AMENDMENTS TO THE DRAWINGS

REMARKS

FIG 2B

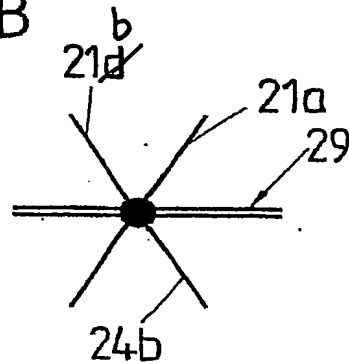
A request is made to revise FIG. 2B and FIG. 2C in the manner illustrated by the red-marked copies being provided herewith. Specifically, in FIG. 2B, reference no. 21d should be changed to 21b. In FIG. 2C, reference number 21e should be changed to 21c and reference number 24e should be changed to 24c. In anticipation of the approval of these red-marked revisions, replacement drawing sheets are being submitted as part of this Amendment Response.
